**Town of Hampden
Planning Board
Wednesday April 13, 2016
Municipal Building Council Chambers
7:00 pm**

Fiberight LLC/MRC: Solid Waste Recycling and Processing Facility

Date: April 11, 2016
To: Planning Board
From: Dean Bennett, Community Development Director
Meeting: Planning Board Regular Meeting April 13, 2016
Re: Fiberight/MRC Site Plan Review Report

Re: MRC/Fiberight Solid Waste Processing Facility Site Plan Review

**WB-67 @ 8 mph
Hampden, Maine
March 25, 2016
Right In and Right Out**

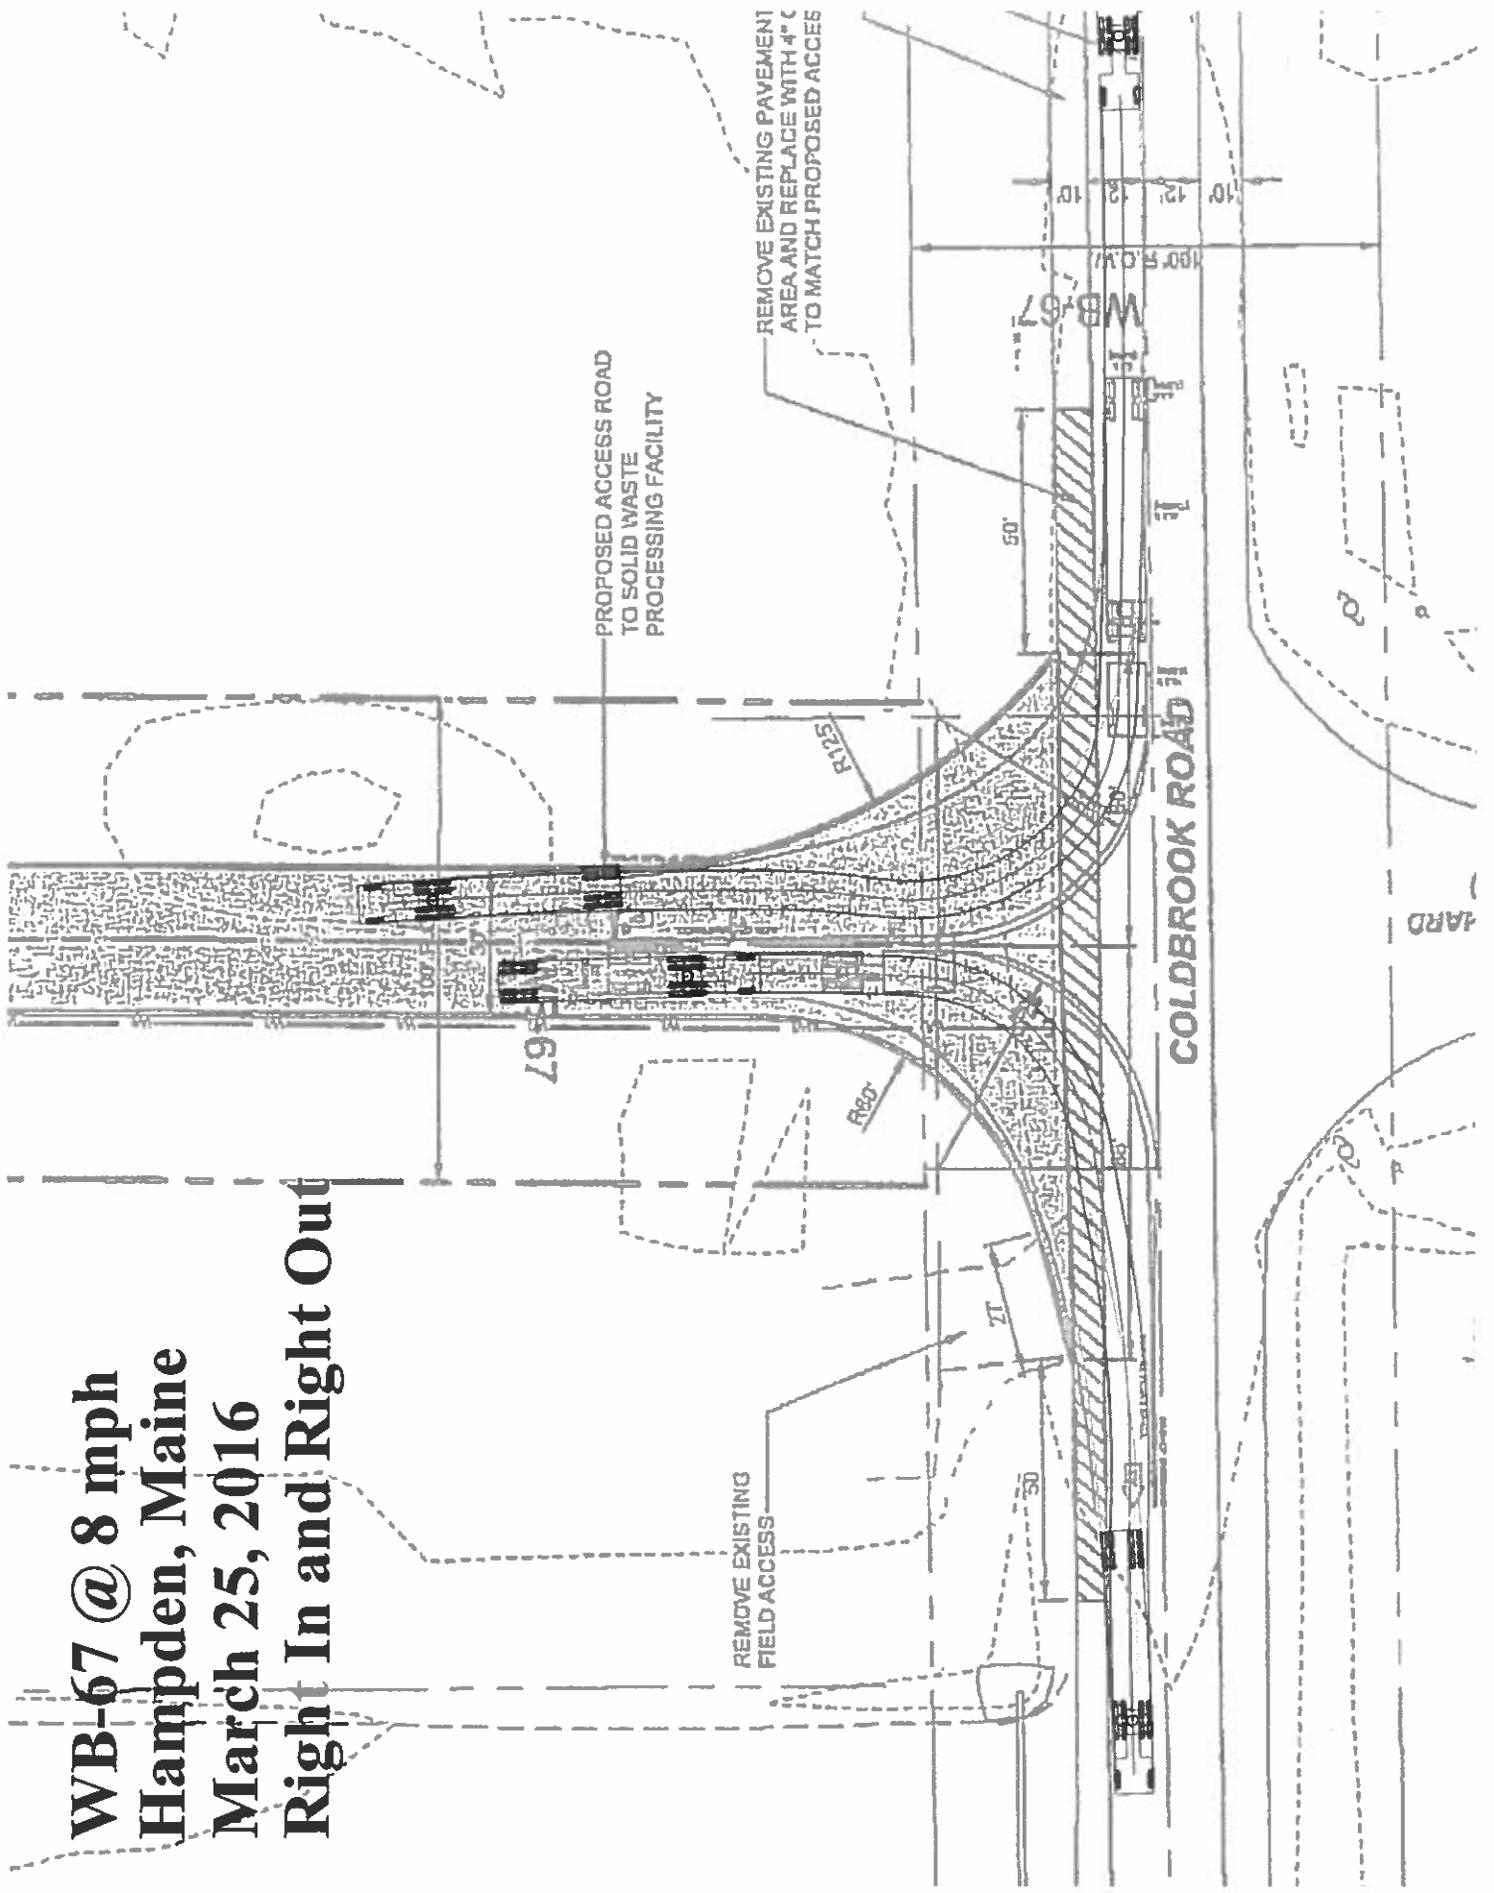
AutoTurn runs performed by Maine Traffic Resources show that a WB-67 tractor trailer truck will need to use all of the access road to make the turn in and out of the facility in the area of the cul-de-sac making it unsafe for other vehicles, particularly for automobiles entering or exiting the parking lots. The access road needs to be widened in this area to assure that trucks do not need to cross centerline to access the facility. AutoTurn runs showed no issues at the Coldbrook Road intersection. The AutoTurn runs are attached for your information.
